March 9, 2010

DOCKET
02-AFC-4C

**RE: REQUEST FOR STAFF APPROVED MODIFICATION: WALNUT ENERGY
CENTER AUTHORITY WALNUT ENERGY CENTER (02-AFC-4C):
INSTALLATION OF MICRO FILTER FEED TANK AND SHADE STRUCTURE**

ZLD - PALL M.F.S.
SHADE STRUCTURE
PLAN @ EL. 113'-9" & SECTIONS

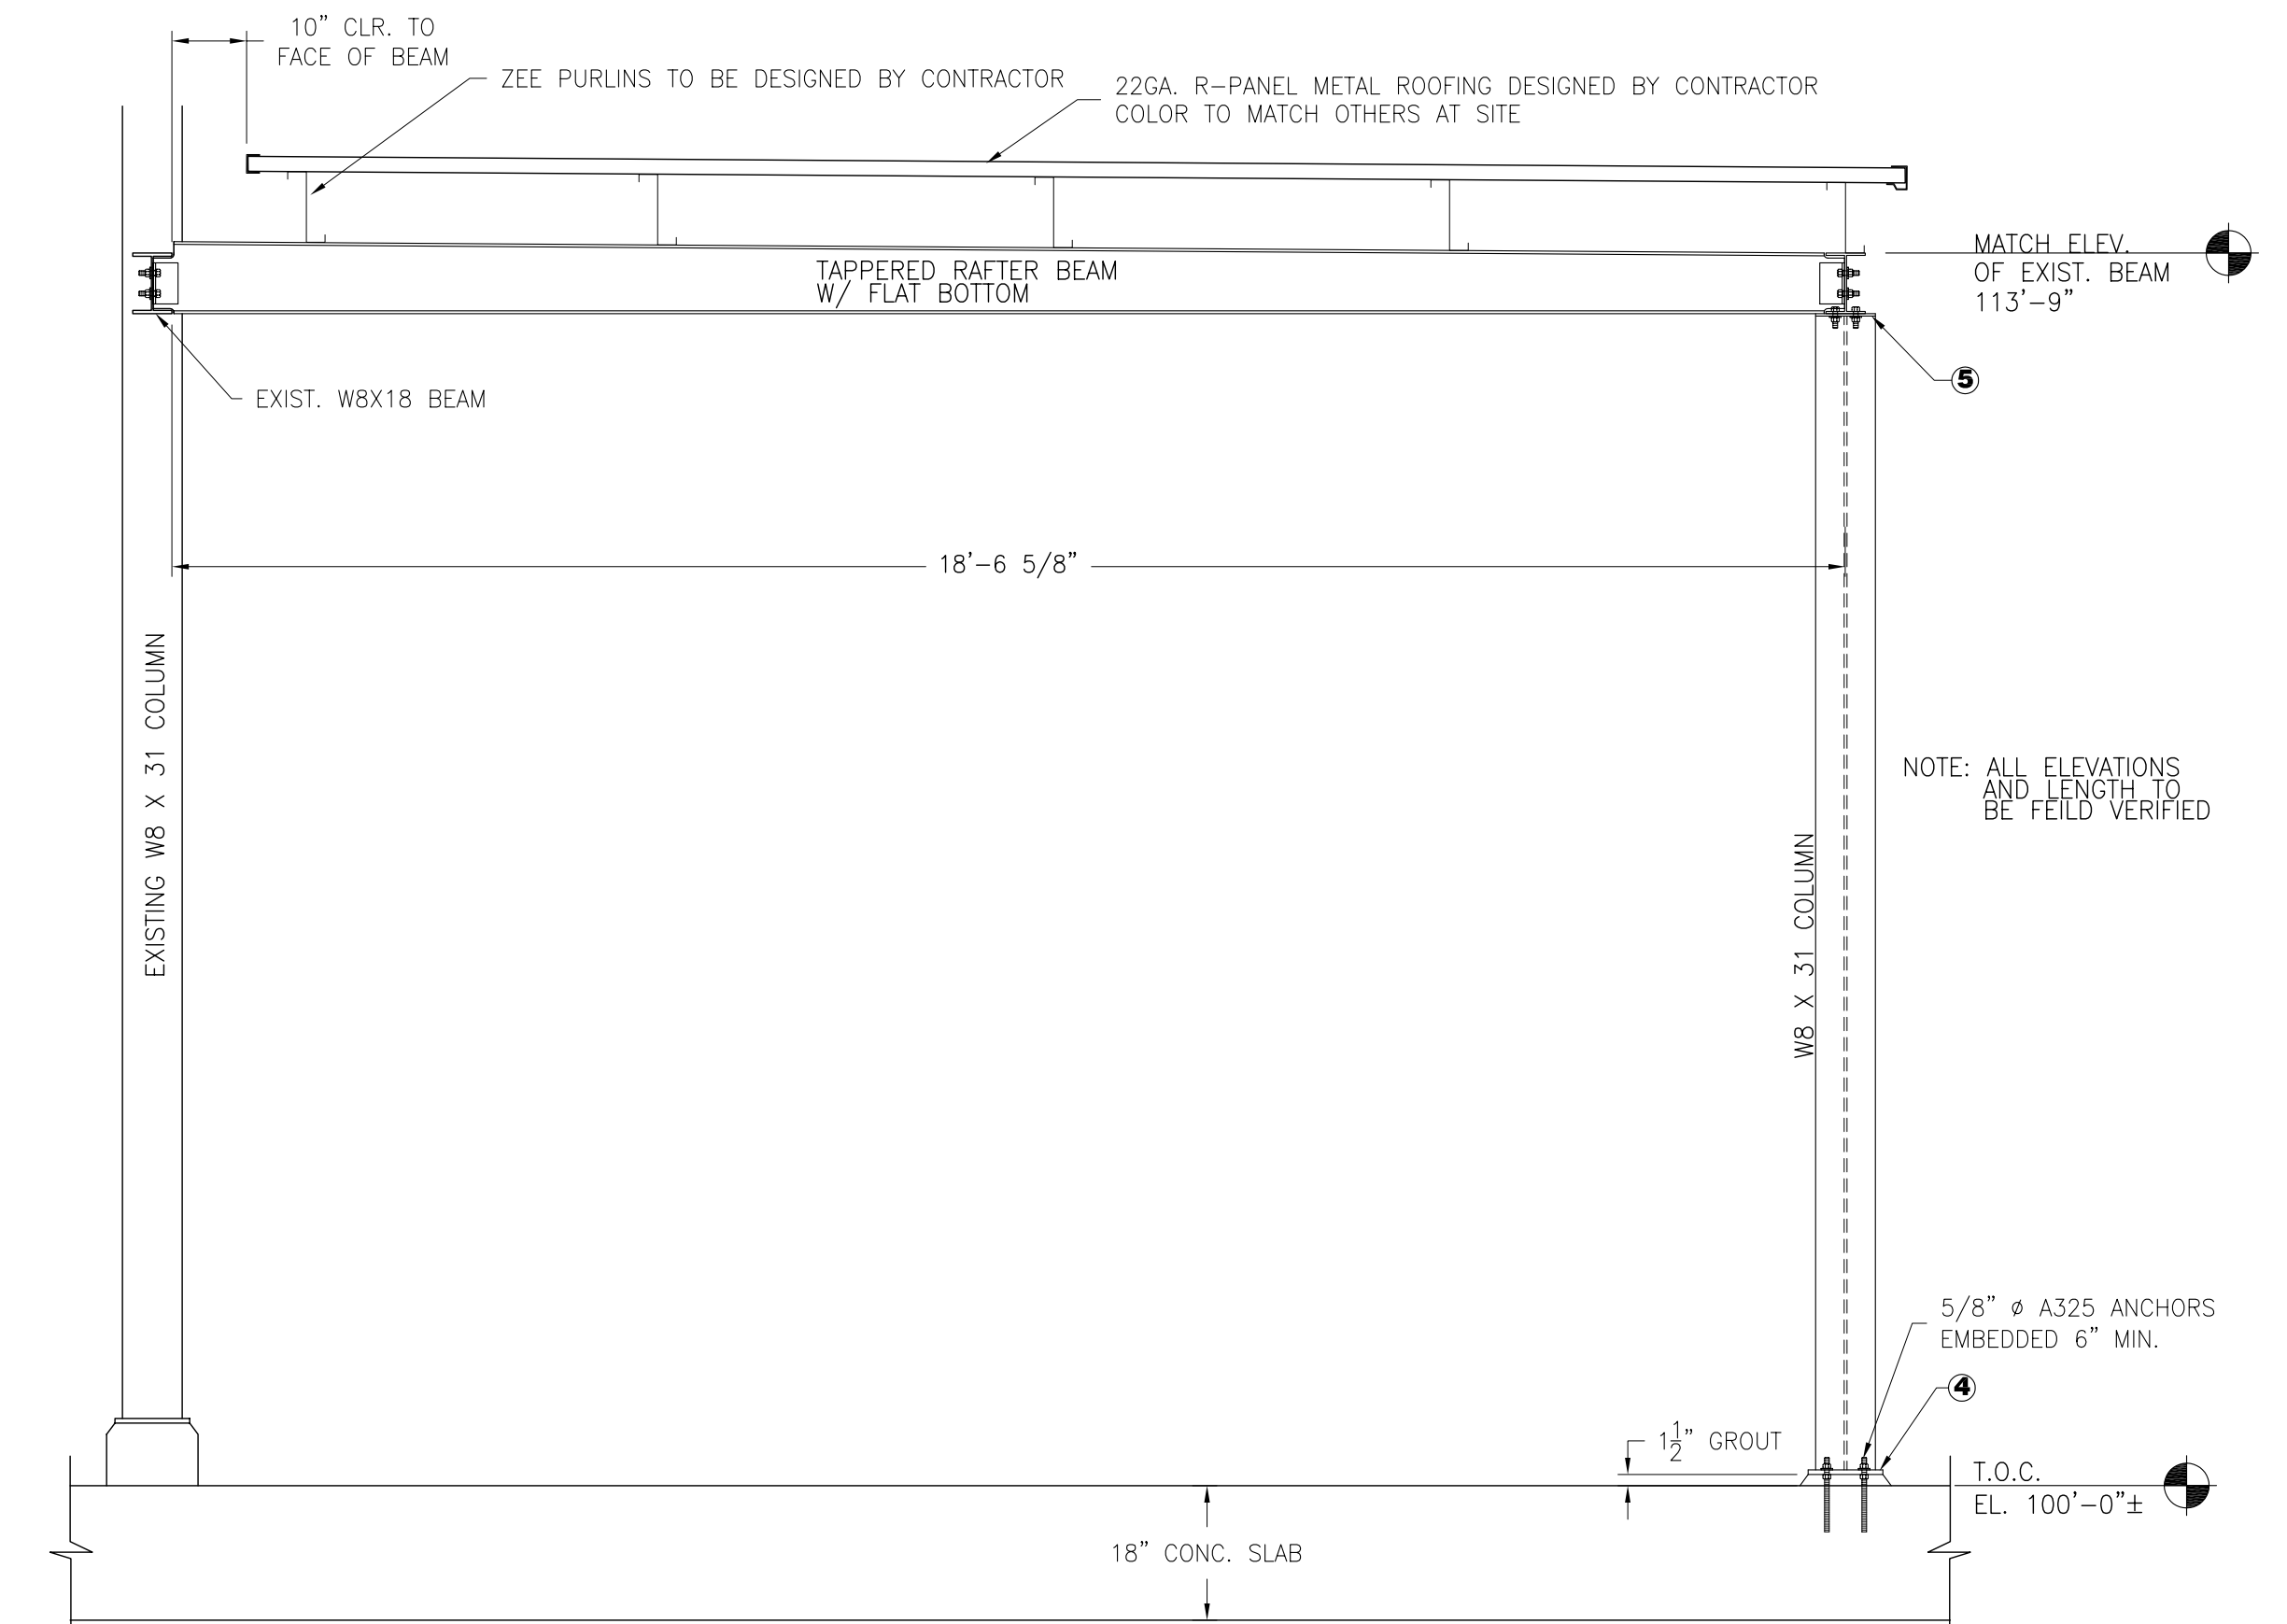
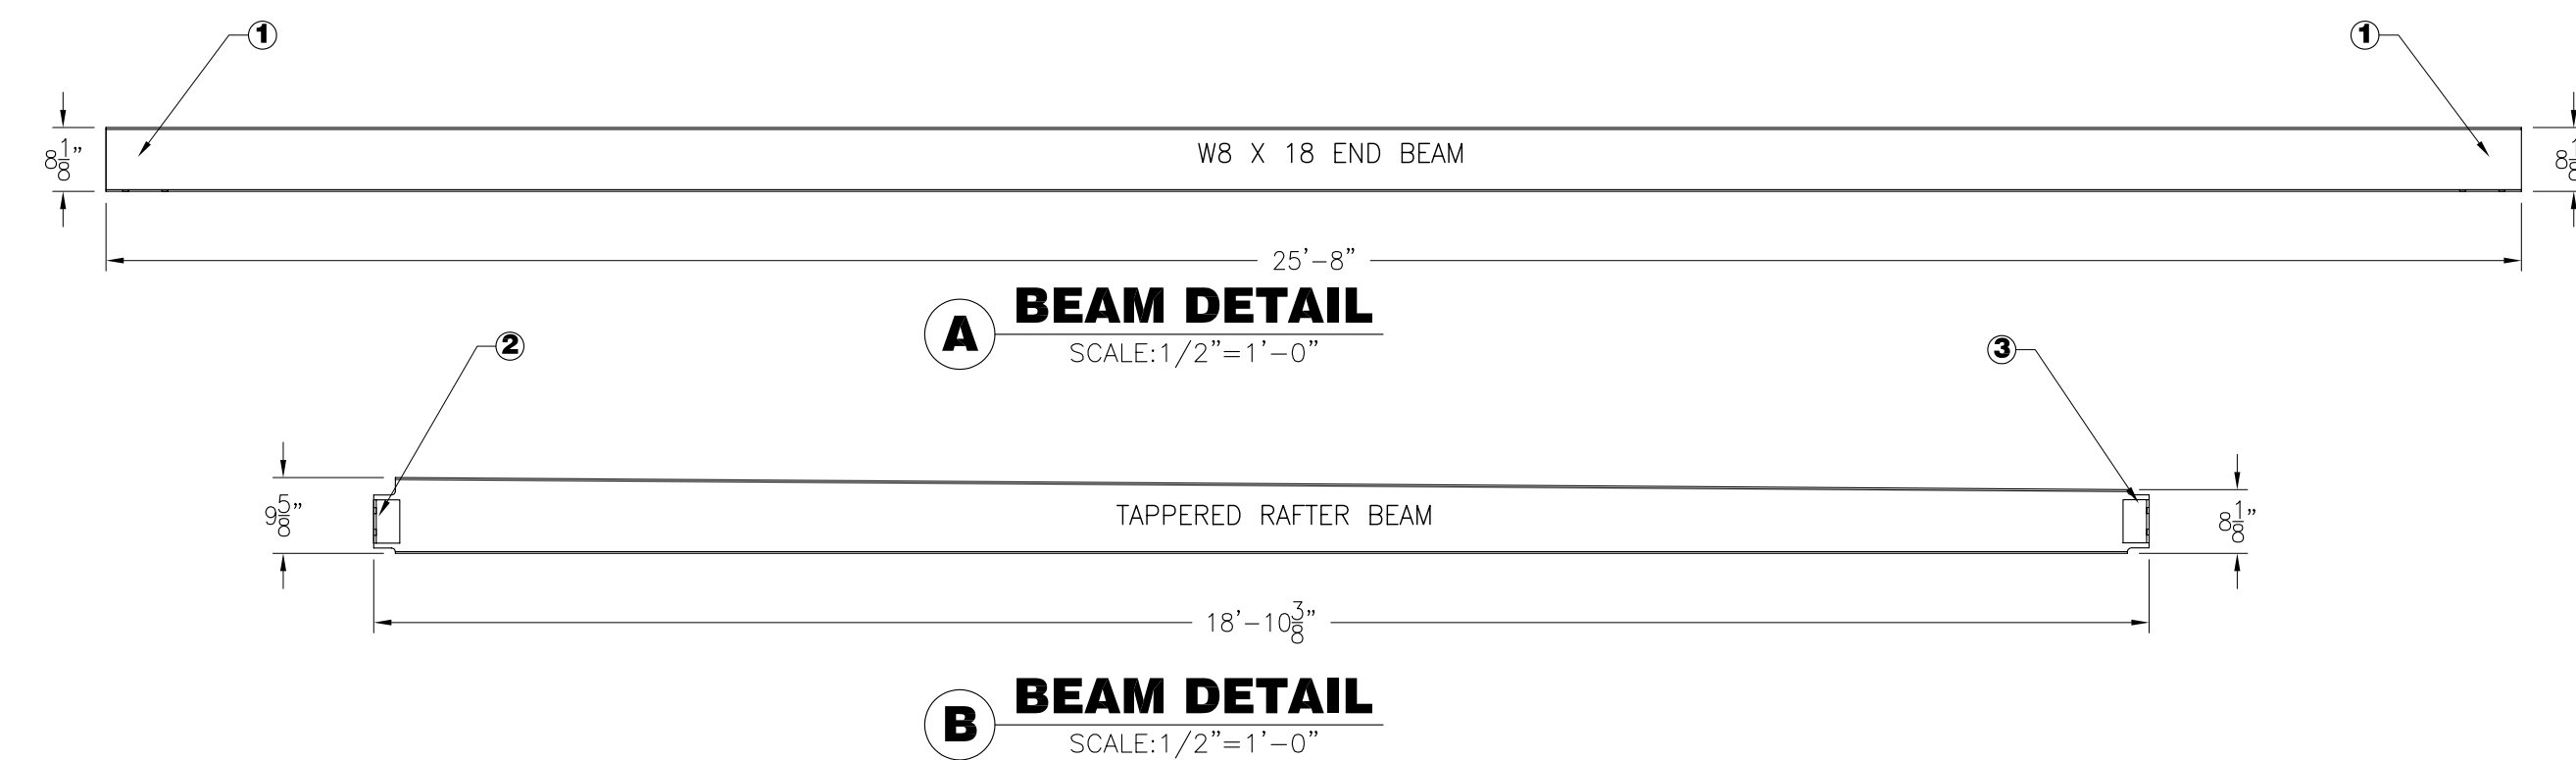
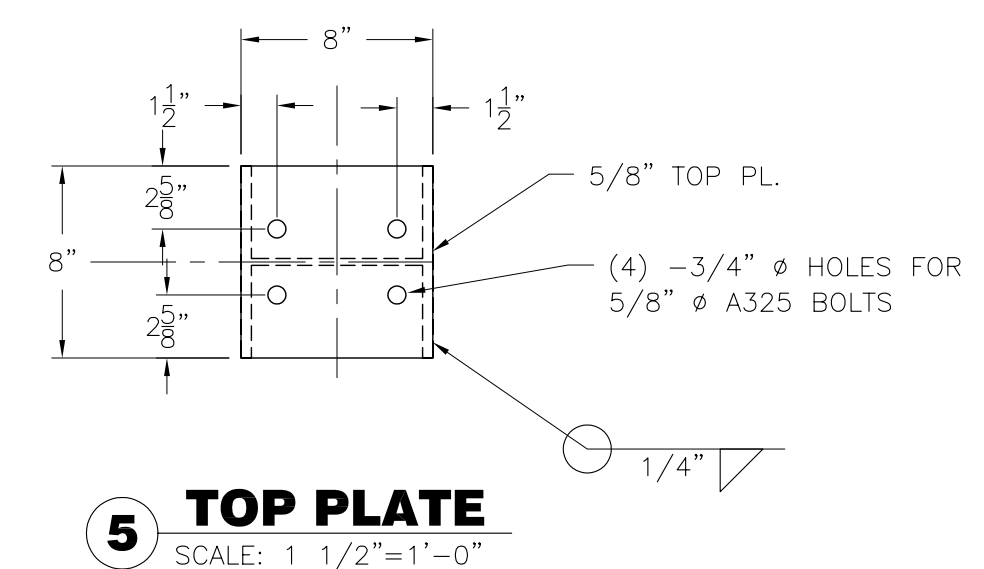
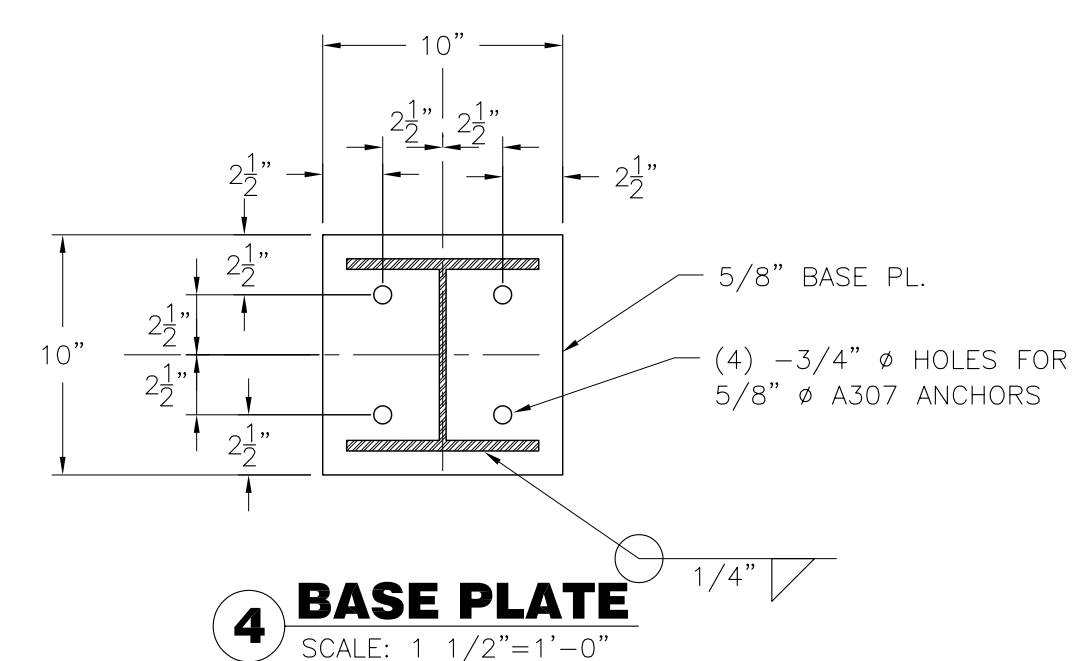
TID proposes to install a shade structure to protect the micro filtration equipment from sun damage. The structure would be located in the WEC ZLD area. It would be 44' long by 18'-6" wide. It would be approximately 13' in height, which is much shorter than much of the equipment and tanks in the ZLD area. The structure would be supported by galvanized steel beams and the metal roof would be painted gray to match the rest of the WEC. Included in Attachment 2 is an engineering drawing of the shade structure. The location of the shade structure is indicated in the aerial of the WEC plant in Attachment 1.
